ATTACHMENT A

Requested Amendment Changes

ATTACHMENT A #3

Pending Safety Analysis Report, Docket 50-170. Remove pages 3-7, replace with pages 3-7, 3-7a, 3-7b. Remove 3-10, replace with 3-10. Remove 3-11, replace with 3-11. Remove Fig 3-5, replace with Fig 3-5A.

Fig. 3-5A Schematic Air Flow Diagram

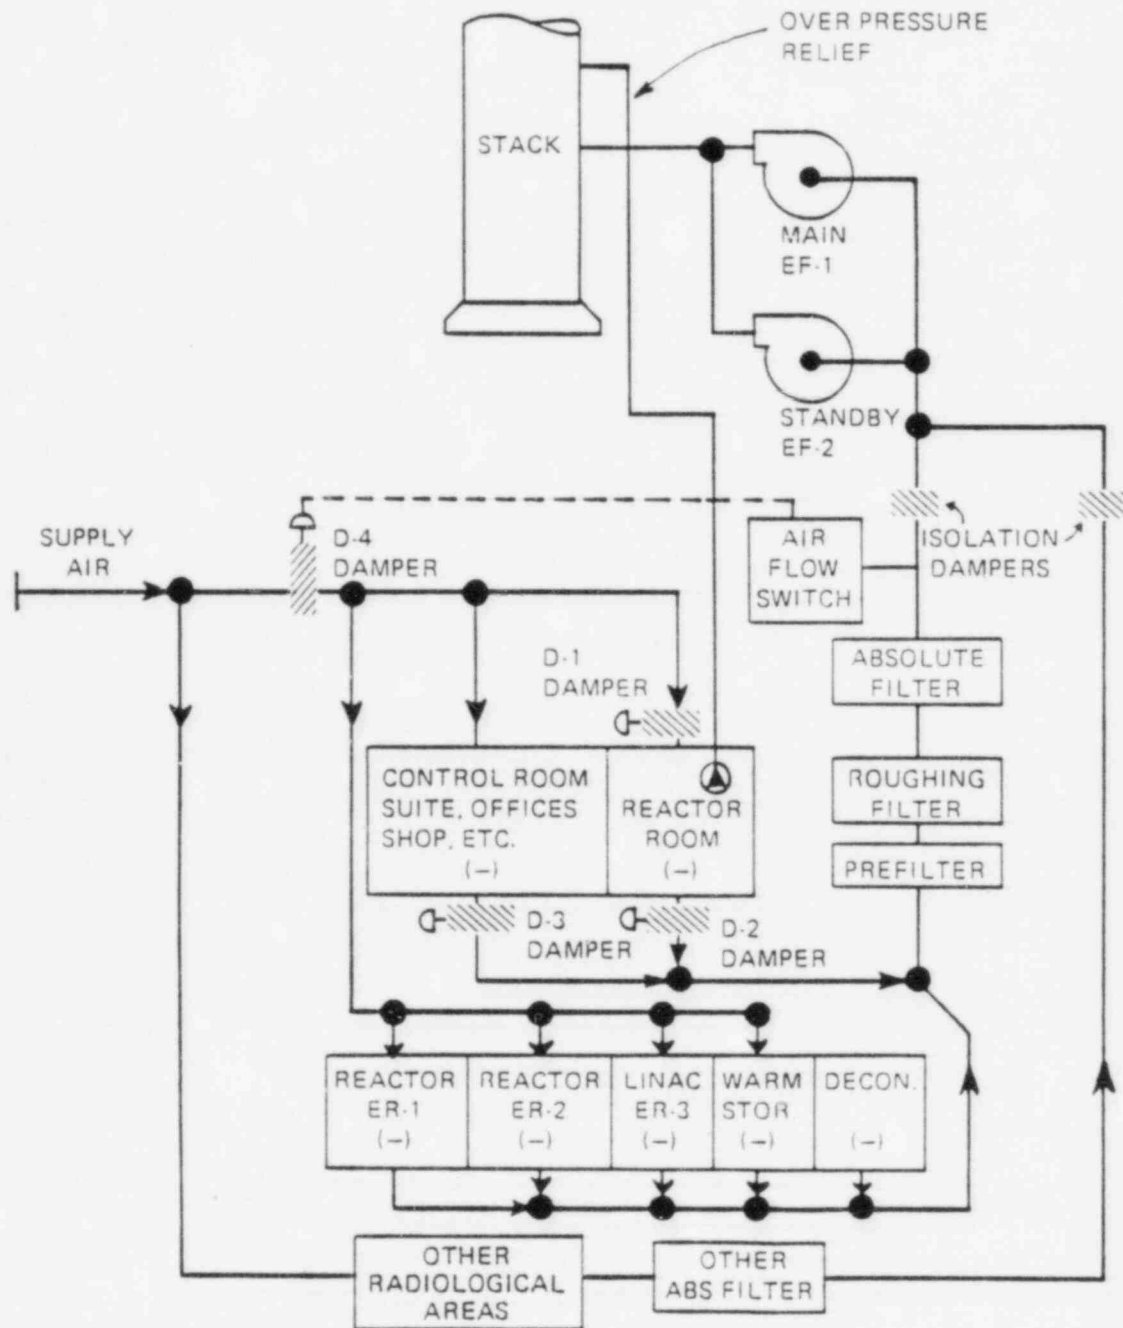
One branch is of special interest in the control of possible airborne radiation hazards that may arise from actions or operations involving the TRIGA reactor. That branch services select areas within the reactor building. Several smaller branches serve fume hoods and other sources of possible airborne radioactive contamination. The reactor branch and other branches are installed in a parallel manner, using the same supply and exhaust. However, the reactor related area is held negative with respect to other areas within the complex. The area of interest is shown in the block diagram (Figure 3-5).

reactor room; the Exposure Rooms 1, 2, and 3; the warm storage and decontamination room; and the reactor control room suite. The branch is subdivided into three parallel legs that service these areas. These areas are supplied air from the building supply air. Air is then single-passed thru each parallel leg, exhausted thru a set of absolute filters, monitored, and then released via the AFRRI stack.

Air from the building system is supplied to the legs of the reactor branch thru a single supply damper. This damper (which allows air movement) is held open only as long as there is airflow in the exhaust ducts beyond the absolute filters. A flow-sensitive switch that senses a loss of exhaust flow would send a signal to close the supply damper, thus stopping the supply of air to the entire branch.

To provide isolation capabilities in the event of airborne contamination, the reactor room air ducts (both supply and exhaust) are provided with sealing dampers. When closed, these dampers prevent air movement into or out of the reactor room via the ventilation system.

These dampers may be opened or closed from three points: a radiation-sensing device to sample air from the reactor room; a manual operate button in the control room; and each damper manually. The dampers are located so that access to them can be achieved without entering the reactor room. The dampers will be a "close on fail" type to insure a safe configuration in the event of system failure.
